MIDLAND INDEPENDENT DESIGN AND CONSTRUCTION VERIFICATION PROGRAM  
MONTHLY STATUS REPORT  
NUMBER 2  
PERIOD MAY 28, 1983 THROUGH JUNE 30, 1983

MIDLAND INDEPENDENT DESIGN AND CONSTRUCTION  
VERIFICATION PROGRAM (IDCV)  
MONTHLY STATUS REPORT  
NUMBER 2  
PERIOD MAY 28, 1983 THROUGH JUNE 30, 1983

ORDER OR CONT. NO. 7220-NE USG AC	JOB NAME MIDLAND 16.2-HGR-MATL
MARK NO. 6-2E8B-6-HIO	NO. 2-659-1A-10(8)
SHEET 2 OF 2

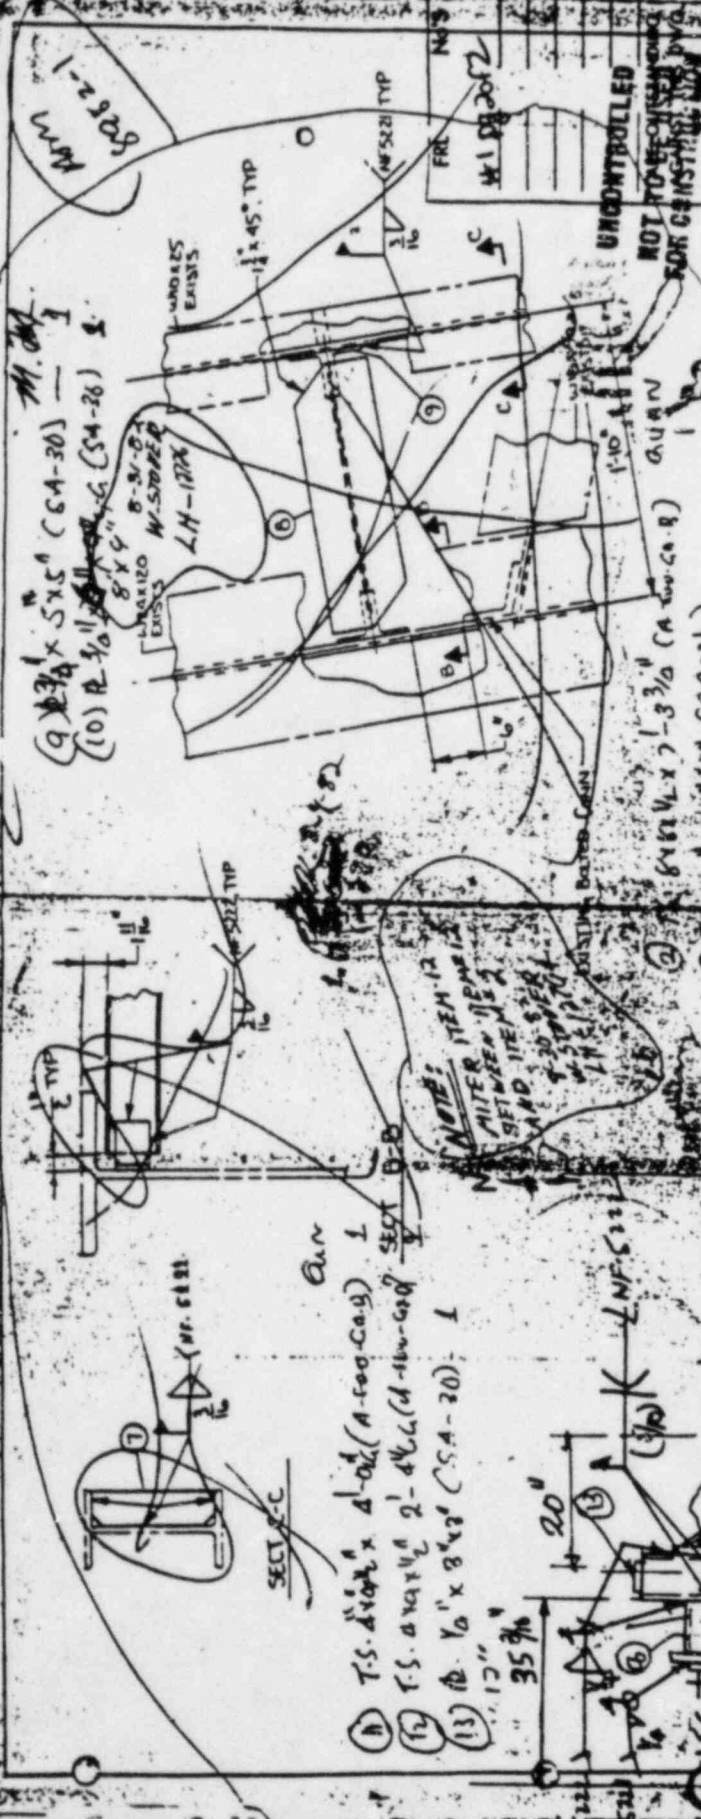
- Hanger H-10, a horizontal snubber, is properly installed in accordance with the red-lined detail hanger drawing. Changes indicated on the drawings were approved by the site resident engineer.
- Hanger location for hanger H-10 was field measured to be approximately 3' from its design location (along the direction of the pipe axis) as shown on the piping isometric drawing.

- Changes to design caused by construction/installation activities may not necessarily be fed back into the design finalization process in an accurate and consistent manner.
- Since the piping isometric drawing is used as input to the piping stress analysis, the piping analysis for this portion of the system may be adversely affected leading to higher support loads and piping stresses than calculated.

Hanger location for hanger H-10 was field measured to be approximately 3' from its design location (along the direction of the pipe axis) as shown on the piping isometric drawing.

Since the piping isometric drawing is used as input to the piping stress analysis, the piping analysis for this portion of the system may be adversely affected leading to higher support loads and piping stresses than calculated.

- Confirm that as-installed dimensions are indicated on the piping isometric drawing - the document controlling input to the piping stress analysis.
- Review existing processes and procedures utilized to ensure that field changes are consistently and accurately reflected in design documentation.

Pursue resolution of finding with cognizant Bechtel engineering personnel and ensure that processes are in place which would ensure that field modifications to the design are accurately and consistently reflected in the design documentation.

The dimensions appearing on the piping isometric drawing utilized to locate pipe hanger H-10 have been changed to reflect the as-measured and as-installed location. Since the piping isometric drawing is being revised to accurately locate hanger H-10, the piping stress analysis will be revised to analyze the as-installed location for hanger H-10. TERA will review the revised piping isometric drawing and piping stress analysis. (The piping isometric drawing is the controlling design document for input to the piping stress analysis). Procedures and processes have been revised and implemented which are designed to ensure that field-generated modifications to hanger locations are compared against the piping isometric drawing.

Bechtel Procedure FPD-2.000, FCR/FCN Procedure, has been implemented as the procedures controlling the revisions to detail hanger dwgs., replacing the previously used red-line procedure. The above actions, when coupled with the CCP & PSDIV programs, indicate that CPCo & Bechtel have implemented significant program modifications to control & verify field-generated changes to design documentation.

Dwg. 7220-H-639, Sh. 14(Q), Rev. 11, Rev. 13 & Rev. 14 & attached redline for H-7  
Spec. 7220-M-326, Rev. B installation inspection & doc. of pipe supports

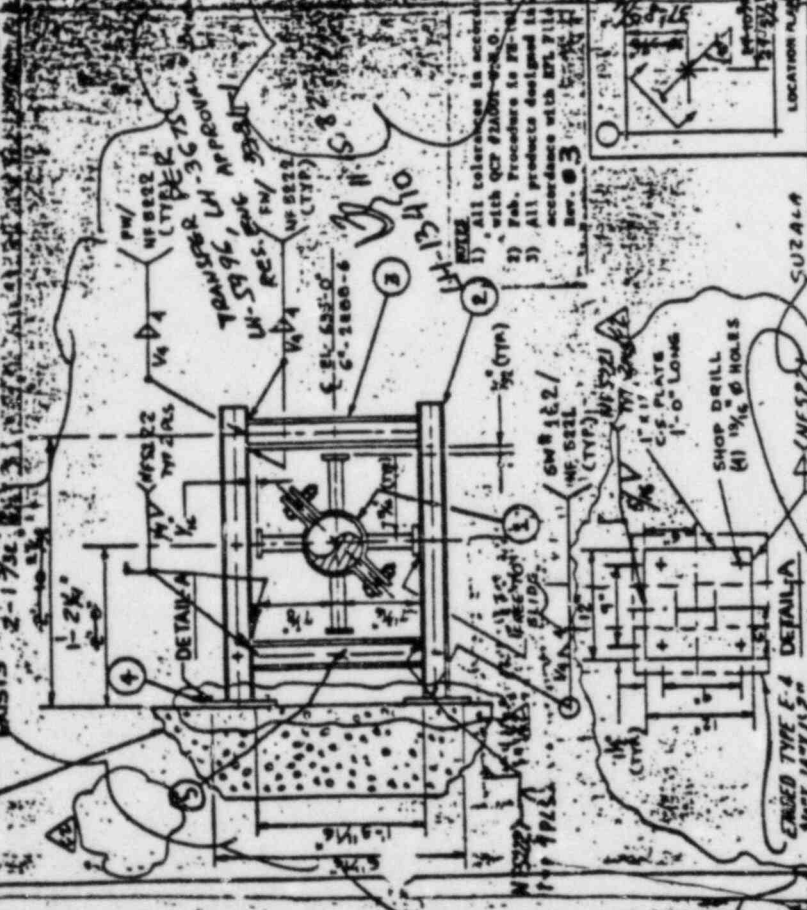
- Red-lined detail hanger drawing shows hanger H-4 on opposite side of 90° elbow than the actual, as-installed location. Red-lined hanger drawing depicts hanger installation on the N-S run of pipe; actual installation is on the E-W run of pipe.
- Piping isometric drawing shows hanger H-4 on opposite side of 90° elbow than the actual, as-installed location.
- Dimensionally the red-lined detail hanger drawing is correct - i.e., dimensions

SIGNIFICANCE OF CONCERN: for locating hanger H-4 are correct but the orientation of the hanger relative to E-W and N-S is incorrect.

- Changes to design caused by construction/installation activities may not necessarily be fed back into the design finalization process in an accurate and consistent manner.
- Since the piping isometric drawing is used as input to the piping stress analysis, the piping stress analysis for this portion of the system may be adversely affected

Detail hanger drawing and piping isometric drawing show hanger H-4 on opposite side of 90° elbow than the actual, as-installed location. The drawings depict hanger installation on the N-S run of pipe-actual installation is on the E-W run of pipe.

Since the piping isometric drawing is used as input to the piping stress analysis, the piping analysis for this portion of the system may be adversely affected leading to higher support loads and piping stresses than calculated.

- Confirm with cognizant Bechtel engineers that the as-installed configuration of Hanger H-4 is incorporated into the detail hanger drawing and the piping isometric drawing.
- Review existing processes and procedures utilized to ensure that the as-installed configuration is consistently and accurately reflected in design documentation.

- The orientation of Hanger H-4 as depicted on the detail hanger drawing & the piping isometric dwg. has been marked to indicate that the as-installed location of the hanger on the E-W run of pipe next to the 90° elbow. The detailed hanger dwg. & piping isometric are being revised & will be reviewed by TERA upon completion of the revision.

- Since the piping isometric dwg. is being revised, the piping stress analysis will also undergo revision to analyze for the as-installed location. TERA will review the revised piping stress analysis.

- Procedures & processes have been revised & implemented which are designed to ensure that the as-installed configuration of piping hangers & supports are accurately and consistently compared against the piping isometric drawing. The above action, when coupled with the CCP and PSDIV programs, indicate that CPCo & Bechtel have implemented significant program modifications to control & verify as-installed configuration to design documentation. TERA continues to evaluate the implementation & outputs of these programs (refer to "Recommendation" section of OCR C-031) as they specifically relate to piping systems within the IDCV systems sample selection boundaries.

Drawing 7220-H639, Sh. 14 (Q), Rev. 11, attached redline foil H-11  
Engineering Evaluation 3201-001-001, pages 7 & 8

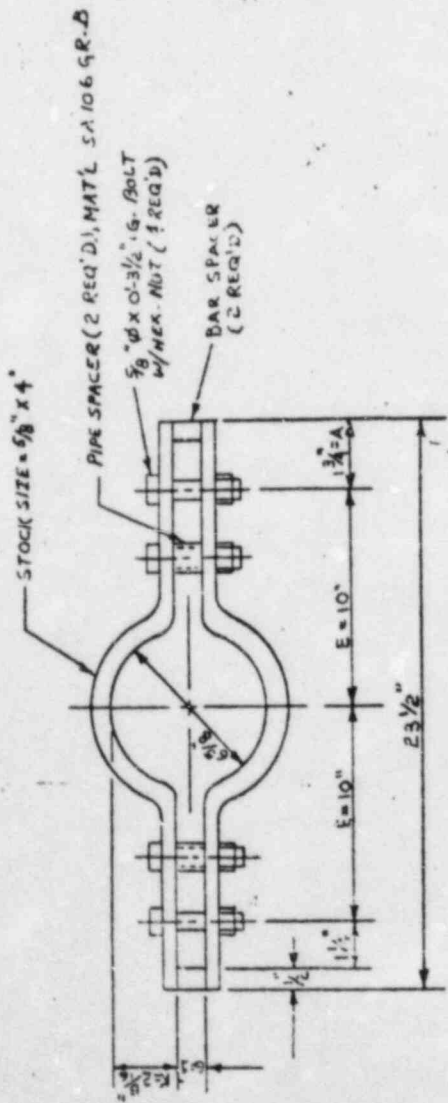
- Hanger H-11 is correctly shown on the detailed red-lined hanger drawing, approved by the cognizant resident engineer.
- Changes depicted on the detailed red-lined hanger drawing were not factored into the piping isometric drawing.
- When changes on the detailed hanger drawing are factored into the piping isometric drawing, a change of 1'2" in the locating dimensions for Hanger H-11 will occur.

- Changes to design caused by construction/installation activities may not necessarily be fed back into the design finalization process in an accurate and consistent manner.
- Since the piping isometric drawing is used as the input to the piping stress analysis, the piping analysis for this portion of the system may be adversely affected leading to higher support loads and piping stresses than calculated.

Hanger location for Hanger H-11 was field measured to be 1'2" from its design location as shown on the piping isometric drawing.

Since the piping isometric drawing is used as input to the piping stress analysis, the piping analysis for this portion of the system may be adversely affected leading to higher support loads and piping stresses than calculated.

- Confirm that as-installed dimensions are indicated on the piping isometric drawing - the document controlling input the the piping stress analysis.
- Review existing processes and procedures utilized to ensure that field changes are consistently and accurately reflected in the design documentation.

Pursue resolution of finding with cognizant Bechtel engineers and ensure that processes are in place which would ensure that field modifications to the design are accurately and consistently reflected in the design documentation.

- The dimensions appearing on the piping isometric drawing utilized to locate pipe hanger H-11 have been marked & the drawing is being revised to reflect the as-measured and as-installed location. TERA will review the piping isometric drawing upon completion of the revision.

- Since the piping isometric drawing is being revised, the piping stress analysis will also undergo revision to analyze for the as-installed location of hanger H-11. TERA will review the revised piping stress analysis.

- Procedures & processes have been revised & implemented which are designed to ensure that field-generated modifications to hanger locations are compared against the piping isometric drawing, Bechtel procedure FPD-2.000, FCR/FCN Procedure, has been implemented as the procedure controlling the revisions to detail hanger drawings, replacing the previously-used red-line procedure. The above actions, when coupled with the CCP & PSDIV programs, indicate that CPCo & Bechtel have implemented significant program modifications to control & verify field-generated changes to design documentation. TERA continues to evaluate the implementation and outputs of these programs (refer to "Recommendation" section of OCR C-031) as they specifically relate to piping systems within the IDCV systems sample selection boundaries.
